Raychem **Part No. 597678**

AA-400 Mark III Body Assy' Replacement Kit.

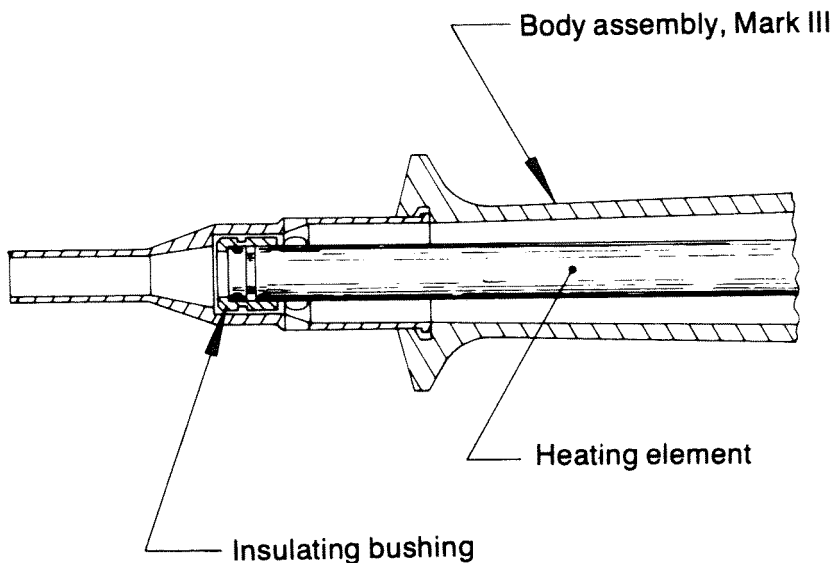
1. The insulating bushing was not required for the MK II body assy'. (green). The enclosed bushing must be used with the MK III body assy'. (yellow)
2. Slide insulating bushing over end of heating element prior to inserting element in body assembly.
